Figure 11.4 - Elevation demolition

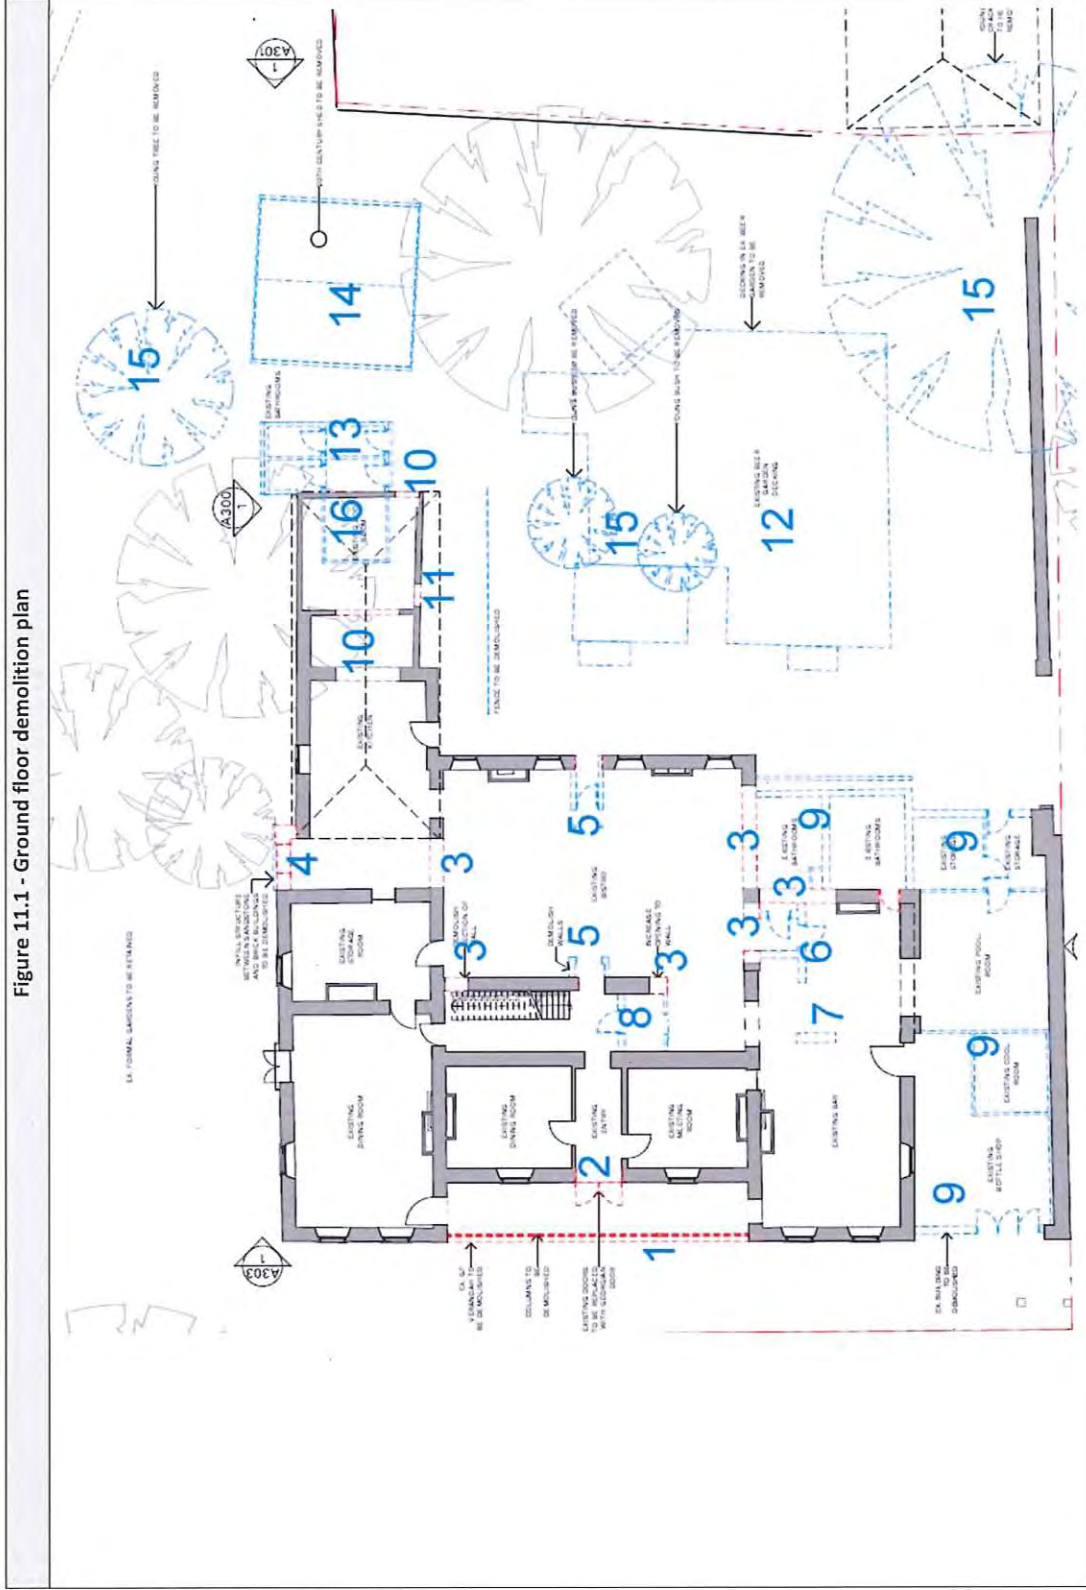
Item	Proposal	Comment on possible heritage impact	Architect's comment
1	Demolition of the 1910s balcony and veranda.	Whilst it is acknowledged that the veranda and balcony has some significance in demonstrating a major renovation phase of the hotel, and that it is somewhat of an iconic and well-recognised feature of the hotel, the rationale for its removal is to return the façade of the hotel to its original, and more significant earlier Georgian form. As per Article 15.4 of the <i>Burra Charter</i> , the removal of the veranda and balcony which is of slight significance, will allow the restoration and greater appreciation of the Georgian heritage values of the building which are of greater significance, both to the site and the general tenor of the township of Ross. The removal of the gable ends and associated decorative infill will allow the more austere and stark Georgian form of the roof and façade to be apparent. This is considered to be a good heritage outcome.	Architects are in agreement with Praxis Environment's comments. Architects would like to add, the overall township of Ross is one of early Tasmanian Georgian architecture. This proposed demolition will increase the legibility of town's Georgian character.

2	Demolition of portions of the front of these roof sections to remove the gable form but to reinstate the hipped form. It is expected that only post-1910 material will need to be removed to achieve this.	Note that the success of the reinstatement of the Georgian tenor of the building relies on both the roof reconfiguration and the removal of the balcony and veranda - the conservation policy promoted an 'all or nothing' approach to removal of major 1910s elements, to avoid a pastiche of some retention and some removal which could act to confuse the evolution of the building.	
3	Removal of kitchen infill.	This is a later added wall and is architecturally awkward. Its removal has no appreciable impact.	
4	Demolition of bottle shop, cool room, toilets, pool room, store and rear entry alcove.	All of these are either heavily adapted mid-c20th infill or later c20th additions of no significance. Note that the significant sandstone boundary wall is to be retained, and no further removal of the existing southern wall of the hotel is proposed. This is considered to be an acceptable outcome to make room for a better-resolved area.

5	Removal of toilet block.	These are later additions (c1960s). Their removal will have no impact.	
6	Removal of modern colourbond garage.	Built in the 1990s. Its removal will have no impact.	
7	Replacement of colourbond roofing with short-sheet corrugated galvanised iron.	A positive heritage outcome in reinstating a more traditional roofing material.

Figure 11.5 - Ground floor development plan

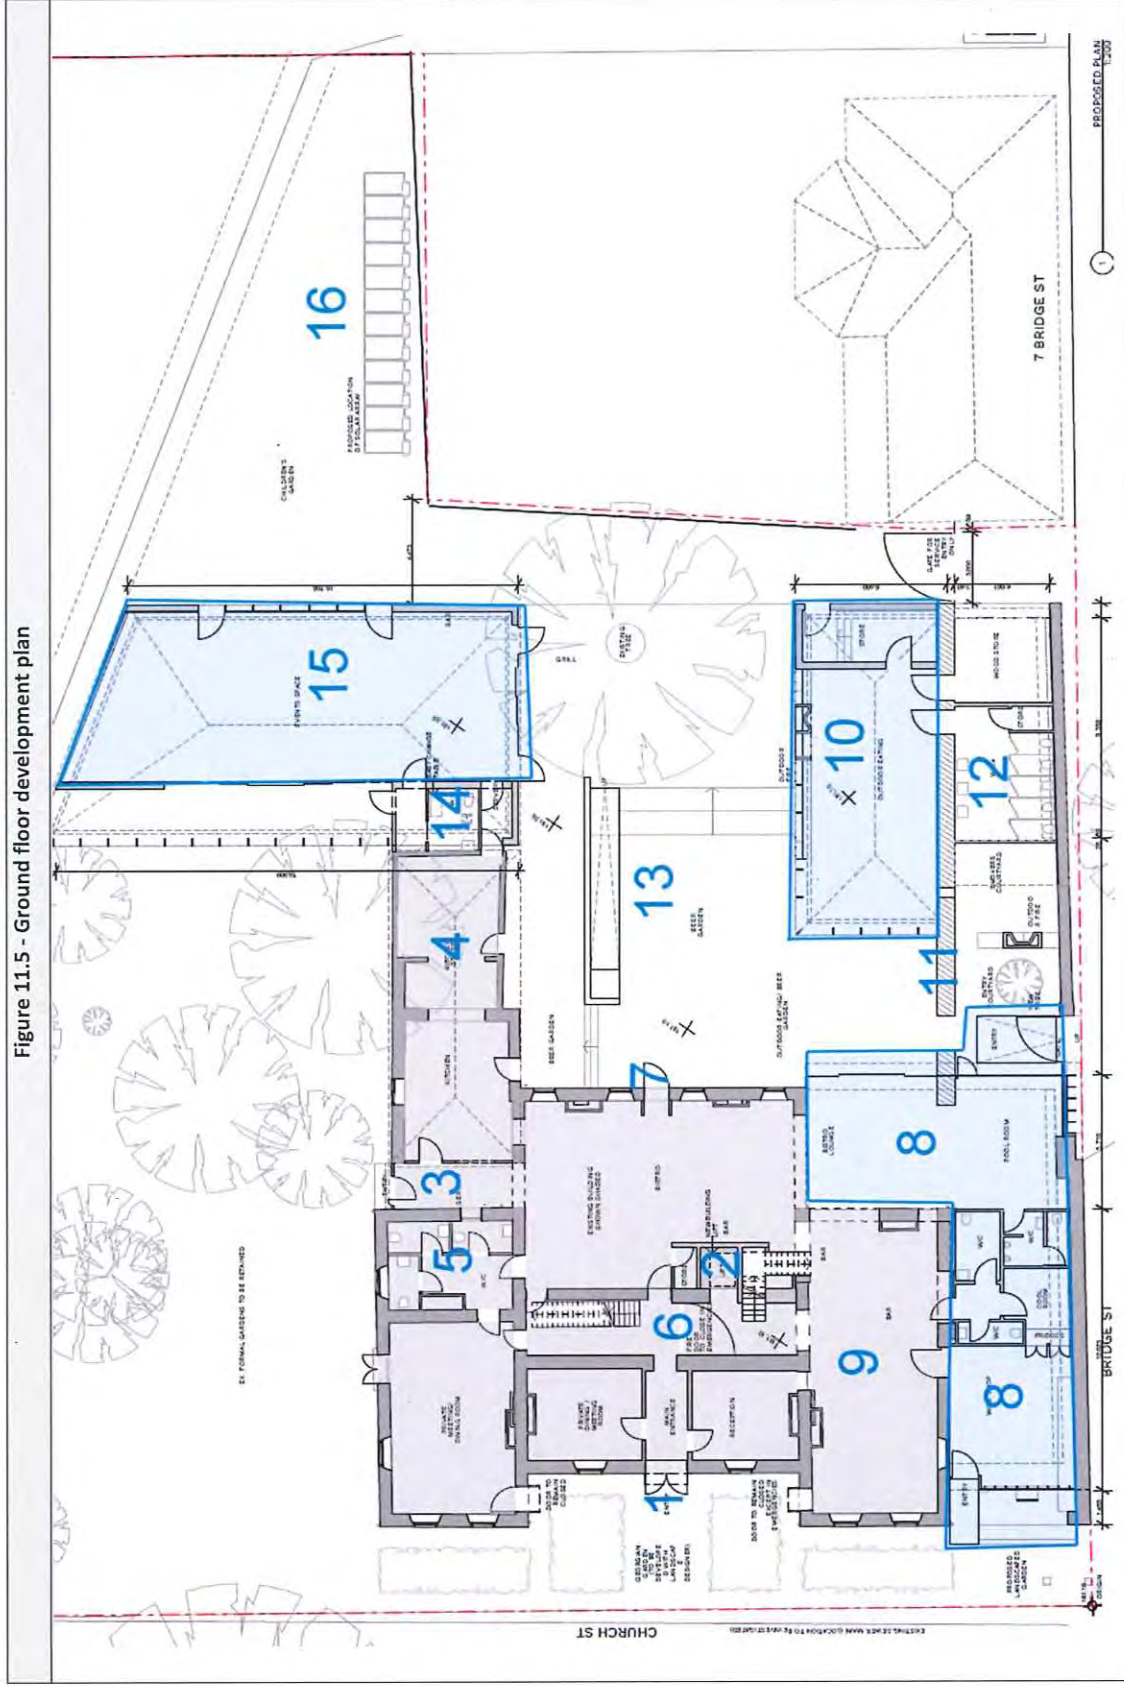
Item	Proposal	Comment on possible heritage impact	Architect's comment
1	New Georgian style doors	More sympathetic doors (possibly a single door and side lights) and a top-light would improve the entrance, with the existing late-c20th doors not particularly sympathetic. Further research on detail design should be undertaken from contemporary country hotels to inform the fine detail design.	
2	Installation of lift and primary stairs.	An iterative process of discussing options between the architects and heritage consultant tested a number of lift options, and it was concluded that this location was the most desirable on-balance with least heritage and visual impact. Whilst it is inevitable that heritage impact will arise with the installation of compliant and fit-for-purpose vertical circulation infrastructure, this is considered acceptable in promoting the ongoing significant use of the building as a viable hotel. Installation in this area will result in the loss of some significant structural fabric. It will only have minimal impact upon detailing, and it is considered that this area of the building is more conducive to such infrastructure than the more formal front rooms/bar areas etc.	For equitable access and for luggage movements to the level 1 hotel suites, a lift is required within the two-storey footprint of the hotel building. After testing many iterations, it was decided locating the proposed lift within the hotel building proper was the visually least disruptive and the most functional to daily hotel operations. The lift overrun will sit within the existing roof cavity. There will be no visual impact on the streetscape. The existing staircase in the building is both non-compliant and unsafe (number of treads, orientation, and short landing at top) and therefore should only be used as a fire exit. To meet emergency and fire safety requirements, an additional staircase is required. Pairing the lift and stair as a 'services core' is both logical and efficient. The stairs and the lift will be developed to be clearly legible as new fabric within the heritage building.

7	New back door.	This is not an original door opening. Whilst no detail has been provided on the design of this door – a modern (but subtle) styling would be appropriate (i.e. not faux Georgian).	
8	New wine shop, bistro lounge, pool room, toilets and cool room.	The location of these items is precededented by the current situation, and the proposal offers a better resolved solution to providing these in support of the ongoing significant use as a hotel. In terms of location, the extension will be low-set, largely concealed behind the

<p>existing sandstone wall. The front setback will be greater than the current front setback of that part of the building, therefore better emphasising the original corner of the hotel. The better resolved floor plan will allow a better flow to the rear of the hotel/beer garden. The exterior form and detailing of this will be discussed in the proposed elevations below.</p>	
9	Refurbishment of bar.	<p>The retention of the bar in the area traditionally used as the bar is a positive demonstration of continuity. The significant detailing around windows will be retained – noting that this area is otherwise devoid of significant detailing. Further detailing is required, however it is unlikely to result in any adverse heritage impact.</p>	
10	New undercover outdoor area and store.	<p>This area will provide functional undercover area within the area traditionally used as a beer garden in an appropriately designed and sited building. This area has a precedent of lightweight structures for shelter and entertainment and the proposal continues that use in a better-resolved manner.</p> <p>The exterior form and detailing of this will be discussed in the proposed elevations below.</p>

11	Hempcrete wall	<p>This is considered to be an appropriate response to providing a hard wall for the insertion of the toilets (between this and the historic boundary wall) – using a natural material but in a modern way. The axis of this wall is in-line with the southern wall of the hotel, which provides some geometric cohesion to the site and also continues the</p>

16	Solar array.	This is considered an acceptable and discrete location for the installation of the array.	
----	--------------	---	--

Figure 11.6 - First floor development plan

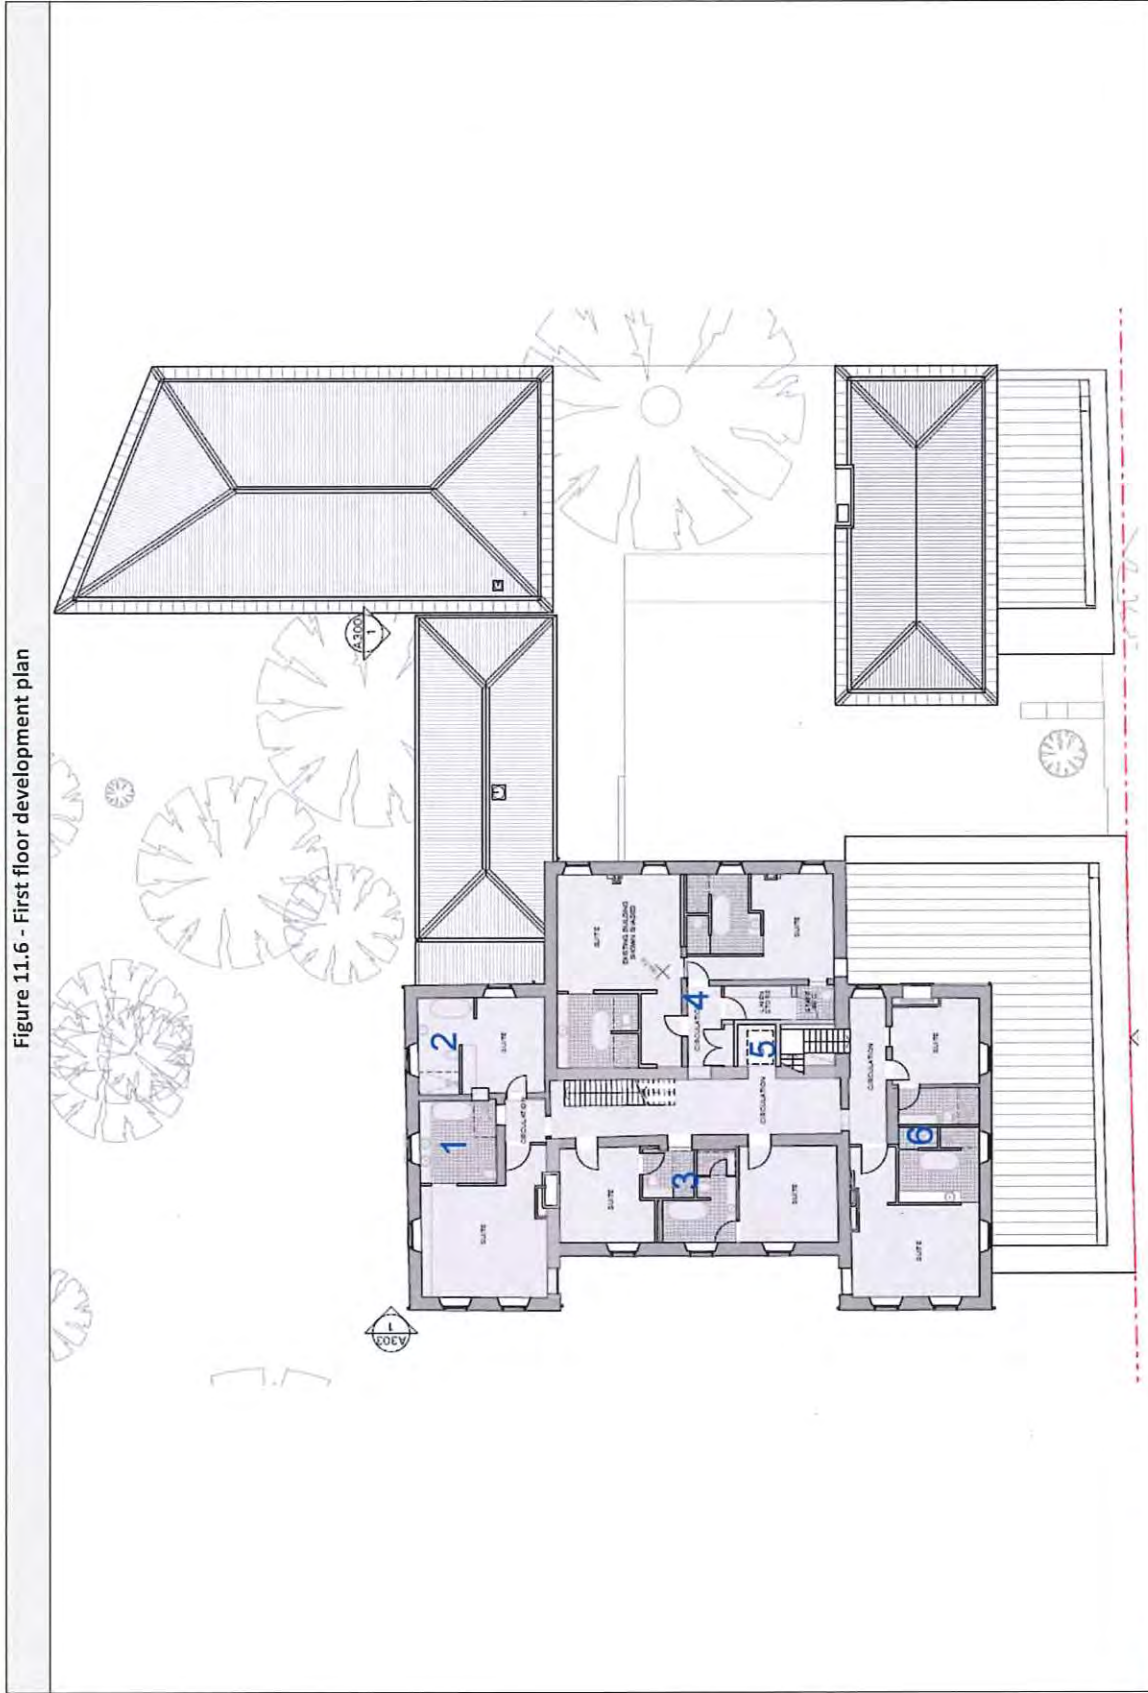
Item	Proposal	Comment on possible heritage impact	Architect's comment
1	New bathroom	This proposed bathroom occupies an ancillary room in this wing and can be installed with minimal structural modification to a room which appears to be devoid of original detailing. This is considered an acceptable outcome.	
2	New bathroom and suite	This area is currently a poorly resolved bathroom area. The proposal will provide for a positive heritage outcome by a better resolved suite, and also allow for the blocking of intrusive window insertions and surface run exterior services.	
3	Two new bathrooms.	Some impact will arise from the reconfiguration of this area, given that it is the only clearly legible original layout on the first floor. Nonetheless, the central room has the lowest integrity of all three rooms, so its division as two bathrooms to serve the more intact rooms either side is considered to be the most acceptable outcome. It is necessary to provide bathrooms for these rooms to allow their viable use as hotel accommodation which contributes to the ongoing significant use of the building, therefore this is considered acceptable. Detail of methods for waterproofing etc. which seeks to maintain significant fabric will be required in the BA process. Note that the door to this room is not original, however the doorframe is – this should be blocked in a reversible manner (the door may be discarded).	Original fabric will only be removed where necessary. Refer to architectural drawing A503 for architectural intent. Nib walls and bulk heads will be retained for future reversibility of proposed works.

4	Reconfiguration of first floor of rear portion of building.	As per comments above, this area has a very low degree of integrity insofar as original fabric and form. The proposed reconfiguration is considered to be an acceptable heritage outcome as it provides for more viable suites in support of the significant ongoing use of the building (note that there is a north-facing window in this area which is omitted from the plans – this is to be retained).	
5	Installation of lift and primary stairs.	An iterative process of discussing options between the architects and heritage consultant tested a number of lift options, and it was concluded that this location was the most desirable on-balance with least heritage and visual impact. Whilst it is inevitable that heritage impact will arise with the installation of compliant and fit-for-purpose vertical circulation infrastructure, this is considered acceptable in promoting the ongoing significant use of the building as a viable hotel. Installation in this area will result in the loss of some significant structural fabric. It will only have minimal impact upon detailing, and it is considered that this area of the building is more conducive to such infrastructure than the more formal front rooms/bar areas etc.	For equitable access and for luggage movements to the level 1 hotel suites, a lift is required within the two-storey footprint of the hotel building. After testing many iterations, it was decided locating the proposed lift within the hotel building proper was the visually least disruptive and the most functional to daily hotel operations. The lift overrun will sit within the existing roof cavity. There will be no visual impact on the streetscape. The existing staircase in the building is both non-compliant and unsafe (number of treads, orientation, and short landing at top) and therefore should only be used as a fire exit. To meet emergency and fire safety requirements, an additional staircase is required. Pairing the lift and stair as a 'services core' is both logical and efficient. The stairs and the lift will be developed to be clearly legible as new fabric within the heritage building.

6	New bathrooms.	These bathrooms are proposed for an area of the building which has a lower integrity – having been previously modified. Noting however that this area does have some joinery which appears to be original (some may have been relocated from elsewhere in the rooms/building when the form was reconfigured. Finer-detail design is required to ensure that this detailing is retained in-situ if

possible, or otherwise reused in this area. Note that what appears to be the original cross-wall is to be retained.	
--	--	--	---	--

Figure 11.7 - Elevation development

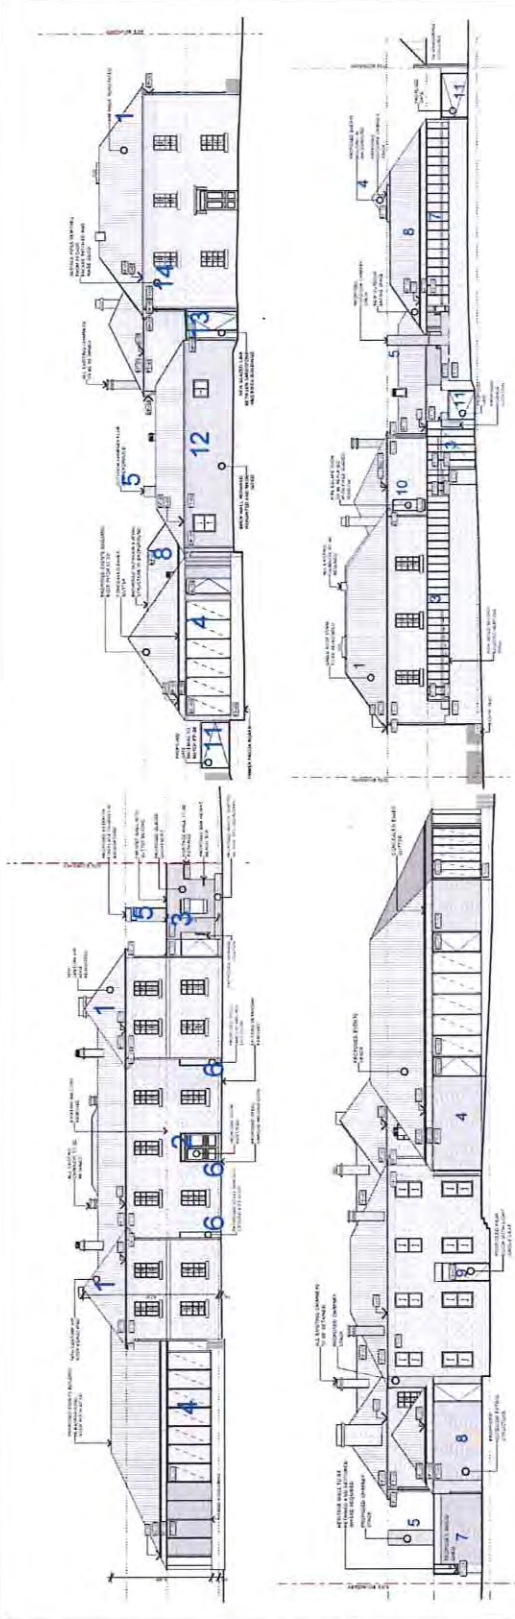
Item	Proposal	Comment on possible heritage impact	Architect's comment
1	Reinstate original hipped roof form.	This is a positive heritage outcome as part of the suite of works intended to reinstate the original Georgian form of the building.	
2	Reproduction Georgian style doors.	More sympathetic doors (possibly a single door and side lights) and a top-light would improve the entrance, with the existing late-c20th doors not particularly sympathetic. Further research on detail design should be undertaken from contemporary country hotels to inform the fine detail design.	
3	New bottle shop, entry, toilets, store etc.	Whilst a more ideal situation would be for no development on this side of the hotel, and for the formerly open section to be re-opened, there is a

4	New function centre.	<p>Although a comparatively large building, this is considered to be an acceptable outcome in providing function space in an area which does not have the heritage sensitivities of the original building. The building will be set well back from the street frontage so as to maintain the dominance of the original building – that setback also buffered by existing plantings which promote some subservience of the building. It will be sited so as to not interrupt the courtyard and to be lightly attached to the existing rear wing. The form is traditional with a hipped roof of comparable pitch to the existing buildings, with an axial relationship to the proposed outdoor eating structure that promotes visual cohesion and reinforcing the courtyard feel of the rear of the site. The detailing will be modern, but within that traditional form this is considered to be an appropriate design response. The splayed end of the building does break from traditional forms, however this is a necessary response to the service easement running through the site. Whilst the</p>

western elevation suggests that this building will have a high degree of visual impact, the reality will be that it is recessive in the streetscape owing to the setback and the presence of established plantings. Overall, this building is considered to be acceptable.	
5	Chimney in courtyard	This is in the tenor of the original design which has a number of chimneys providing vertical interest. This is an acceptable addition.	
6	Steel shrouds around exterior doors.	Whilst any sort of awning or door shroud was unlikely to have been part of the original design intent (and may have been why a veranda was desired) it is understood that these are necessary for protecting the entrances from the elements. It is proposed that these be flat folded steel, painted black and it is recommended that a small (even <10mm) standoff from the sandstone façade be included (i.e. and that these be freestanding). These are designed to be as subtle and recessive as practicable and are considered an acceptable outcome. To install 'faux-Georgian' awnings, or any other 'heritage style' awning would not be desirable, nor would something overly articulated and modern.

<p>room, this structure is considered to be a suitable means of providing additional entertainment space for the hotel.</p> <p>The design utilises a roof pitch similar to that of existing buildings, and that of the proposed function centre. The location of the building promotes the enclosure and inward-facing nature of the courtyard. Whilst the materials palette is modern, the form of the building will sit neatly with the complex of buildings and is not considered to have any adverse heritage impact.</p>	
9	New back door.	<p>This is not an original door opening. Whilst no detail has been provided on the design of this door – a modern (but subtle) styling would be appropriate (i.e. not faux Georgian).</p>	
10	Fire escape door to be infilled with glazing.	<p>This is an acceptable outcome given the redundancy of that door with the new vertical circulation system in the building. A better outcome would be for this to be infilled with like-for-like masonry, however the proposal is acceptable in any case.</p>
